## G. APPENDIX G – PUBLIC AND AGENCY COMMENTS

The Federal Highway Administration (FHWA) and Colorado Department of Transportation (CDOT) received 64 comments on the DEIS during the 45-day comment period. The comments received were submitted in writing and verbally at the public hearing (held December 8, 2011), mailed directly to CDOT, or were submitted in email form via the project website. The Environmental Protection Agency, City of Pueblo Historic Preservation Commission, Colorado Parks and Wildlife, St. Charles Mesa Water District, U.S. Army Corps of Engineers, and the U.S. Department of the Interior submitted comments to the lead agencies. Two petitions were submitted: 49 individuals signed the Eiler's

Thank you for the opportunity to comment on the Draft Environmental Impact Statement for the New Pueblo Freeway Project. As we are already involved in the ongoing Section 106 discussion I will keep our comments brief and related to the most important issues.

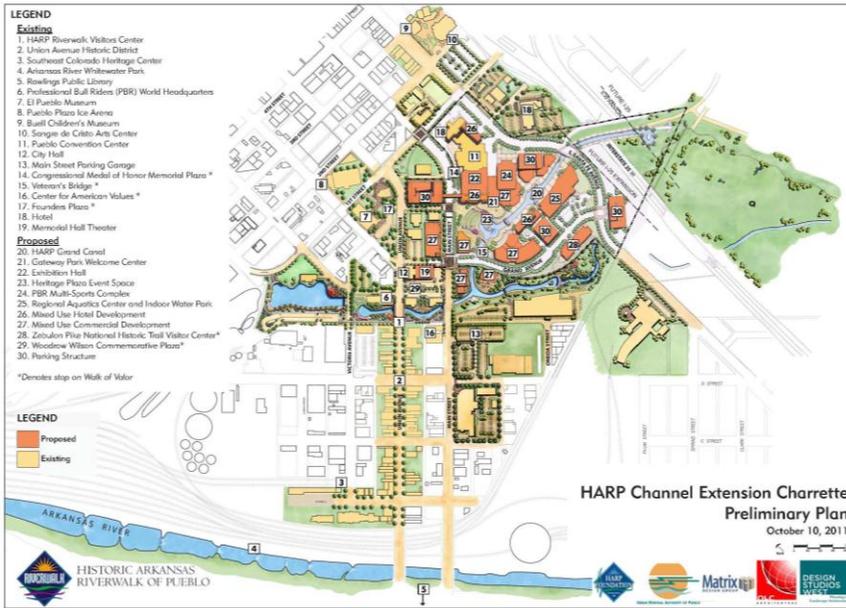
Comment		Response
<p><b>Comment Number:</b> 09</p>	<p><b>Name:</b> James Munch, Historic Arkansas Riverwalk of Pueblo (cont'd)</p>	
<div data-bbox="195 362 831 841"> <p style="text-align: center;"><b>Phasing</b></p> <p><b>Phase 1</b></p> <ul style="list-style-type: none"> <li>• Exhibition Hall</li> <li>• Hotel</li> <li>• Parking Structure</li> <li>• Channel Extension to Santa Fe</li> </ul>  </div>		
<div data-bbox="195 862 831 1341"> <p style="text-align: center;"><b>Phasing</b></p> <p><b>Phase 2</b></p> <ul style="list-style-type: none"> <li>• Multi-Use/ PBR Arena</li> <li>• Gateway Welcome Center</li> <li>• Gateway Park Amphitheater</li> <li>• Mixed Use Commercial</li> </ul>  </div>

Comment		Response
<p><b>Comment Number:</b> 09</p>	<p><b>Name:</b> James Munch, Historic Arkansas Riverwalk of Pueblo (cont'd)</p>	
<div data-bbox="195 350 831 833"> <h3 style="text-align: center;">Phasing</h3> <p>Phase 3</p> <ul style="list-style-type: none"> <li>• Santa Fe Realignment</li> <li>• Channel East Extension</li> <li>• Aquatics Center</li> <li>• Hotel Addition &amp; Parking</li> <li>• Main Street Mixed Use &amp; Parking</li> </ul>  </div>		
<div data-bbox="195 854 831 1336"> <h3 style="text-align: center;">Phasing</h3> <p>Phase 4</p> <ul style="list-style-type: none"> <li>• Hotel &amp; Parking Structure</li> <li>• Grand Mixed Use &amp; Parking</li> <li>• Santa Fe Mixed Use &amp; Parking</li> <li>• National Trail Center</li> <li>• Parking Structure</li> </ul>  </div>

Comment		Response
<p><b>Comment Number:</b> 10</p>	<p><b>Name:</b> James Munch, Historic Arkansas Riverwalk of Pueblo</p>	<p><b>Response to 10</b></p> <p>10-1 Thank you for providing us with the adopted plans illustrating the easterly extension of the Historic Arkansas Riverwalk of Pueblo (HARP). As indicated in the response to <b>Comment #09-1</b>, CDOT has incorporated the adopted plan into <b>Section 3.8 Land Use</b> and considered the benefits and impacts that the Preferred Alternative could have on the adopted plan.</p> <p>The HARP was included in the Downtown Viewshed for the visual analysis. The roadway would be elevated 35 feet above existing I-25 elevations, making the highway more visually apparent than it is today between 13th Street and 6th Street. Retaining walls and fill slopes along the raised portions of the roadway would also become more visually dominant through downtown.</p> <p>The I-25 New Pueblo Freeway Aesthetic Guidelines (see <b>Appendix C</b>) will be used during final design to identify appropriate aesthetic design elements to ensure compatibility within the community and each viewshed. The following mitigation measures are being considered for visual enhancements: gateway features for city boundaries, downtown, and neighborhoods; architectural treatments on retaining walls, bridges, and other structures designed to reflect the architectural character of the surrounding area; and landscaping with native vegetation, including trees and shrubs. CDOT remains committed to coordinating with HARP during final engineering design to minimize or avoid disruption of adopted development plans and to minimize visual impacts throughout the City of Pueblo.</p>
